Product Change Notification

Product Group: VISHAY / June 8th 2017 / PCN-SF-192-2017 Rev 0 page 1/2

HIGH FREQUENCY CH02016 SERIES

BEFORE

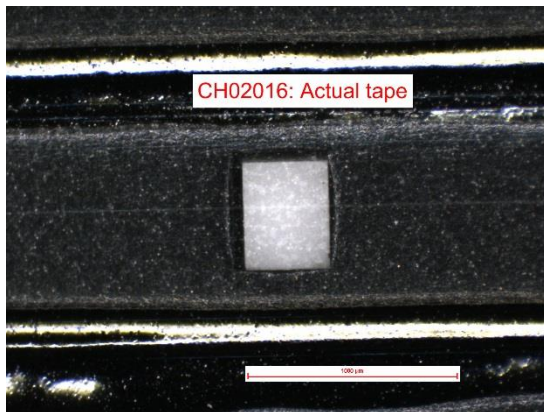
Green Ink added on the rear side of the CH02016 resistor and new tape and reel

Green side of the CH parts
